## Proposal for a new supplement to the 02 series of amendments to UN Regulation No. 138

The text reproduced below was prepared by the experts from OICA in order to clarify the original intent of the Task Force on Quiet Road Transport Vehicles (TF QRTV) conclusion. The modifications to the current text of the UN Regulation are marked in bold for new or strikethrough for deleted characters.

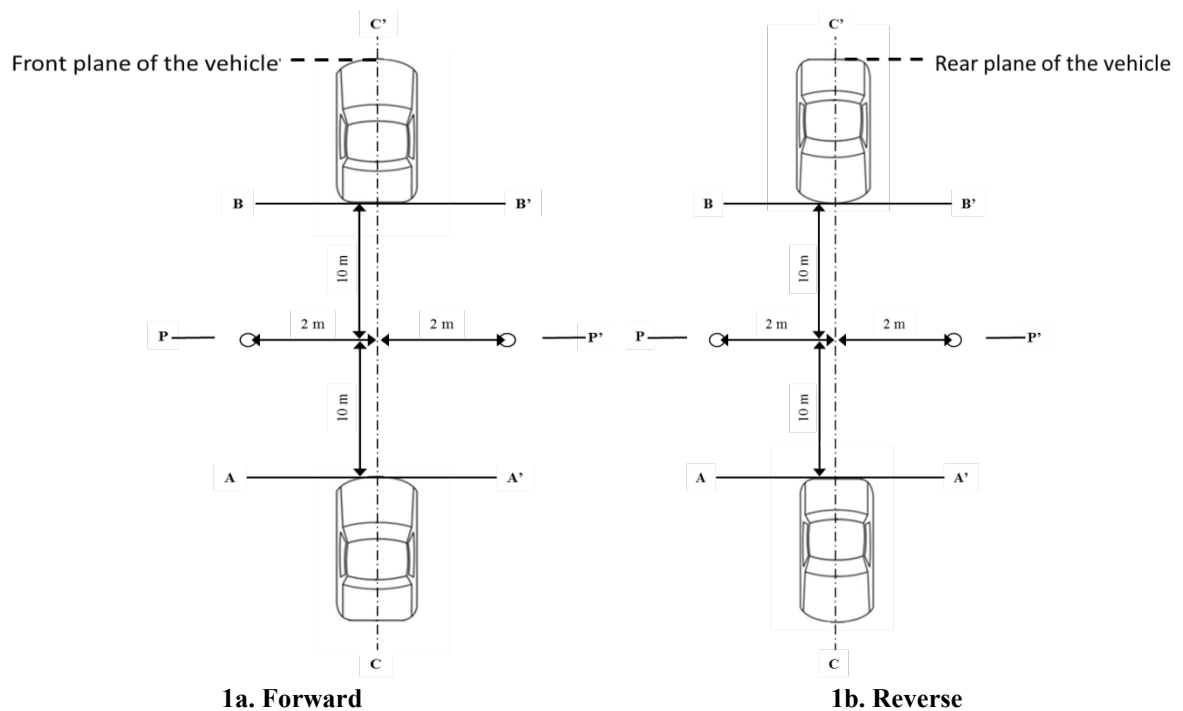
\*) **5 km/h is not mandatory for Method (A)** ~~not for Method A "~~

With the added text about the conditions for verification of frequency shift in paragraph 4.3.1. there is no need for general exclusion of 5 km/h for Method (A). Instead the speed of 5 km/h may be increased to the minimum speed that works for the test.

Figures 1a and 1b  
**Measuring positions for vehicles in motion outdoor**

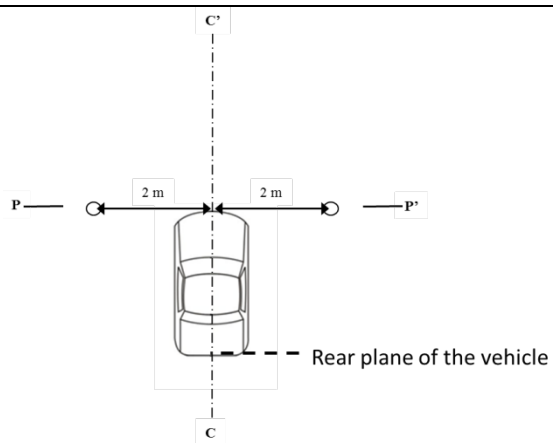
Correction of the figure texts to clarify that the illustrated measurement set-ups are showing the microphone positions relative the front plane and the rear plane respectively.

Figures 2a and 2b  
**Measuring positions for vehicles in motion indoor and in standstill**  
~~additional 2 microphones needed at the front and in the back in 2 m distance~~

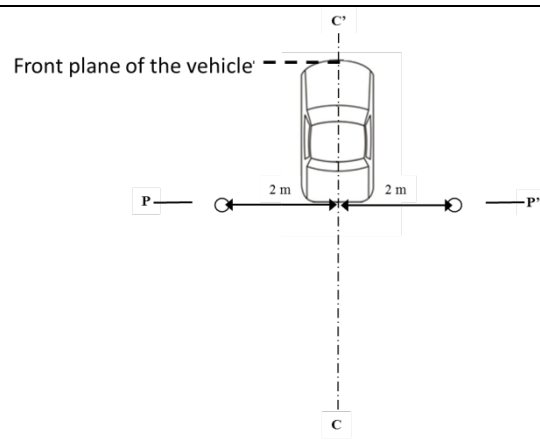
**2a. Forward** Measuring position at the front plane of the vehicle

**2b. Reverse** Measuring position at the rear plane of the vehicle

The microphone set-up of figures 2a and 2b are required for both forward and reverse testing.

The microphone set-up of figure 2a is required for the measurement of frequency shift.

Added text to clarify that the microphone set-up in Figure 2a and/or 2b shall be used.

Figure 3  
Minimum space to be qualified as Semi-Anechoic chamber

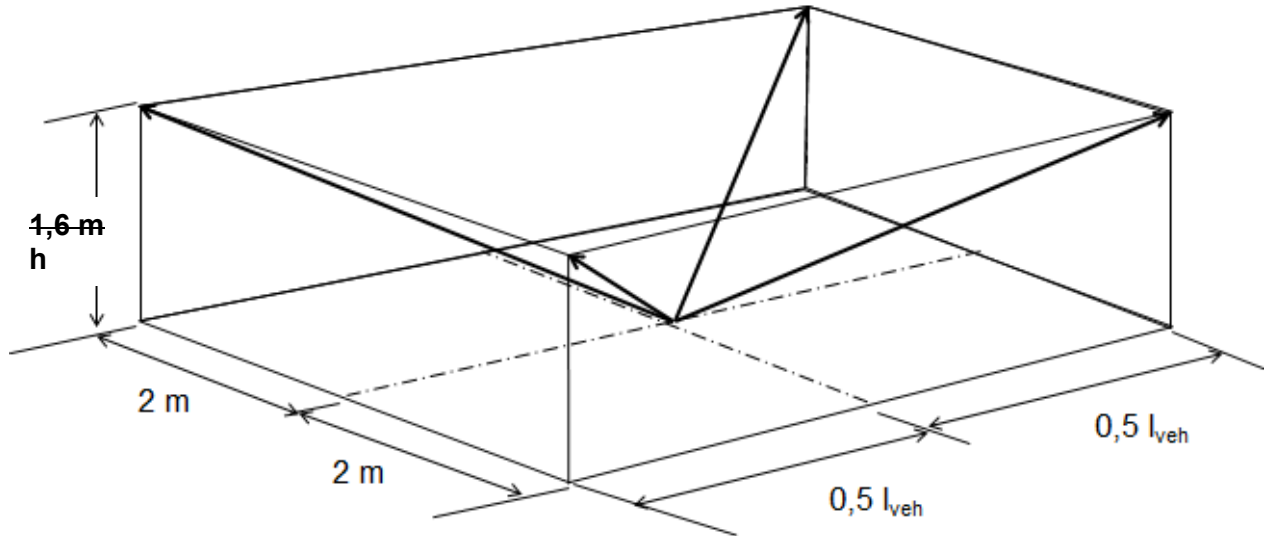
The height  $h$  shall be at least  $1,2\text{ m}$  if the test in this annex is done with 1 microphone at each side. The height  $h$  shall be at least  $1,6\text{ m}$  if 5 microphone array at each side is used.

The figure description and the figure has been modified to cover both the one-microphone set-up as well as the five-microphone set-up defined in Annex 3, paragraph 3.1.
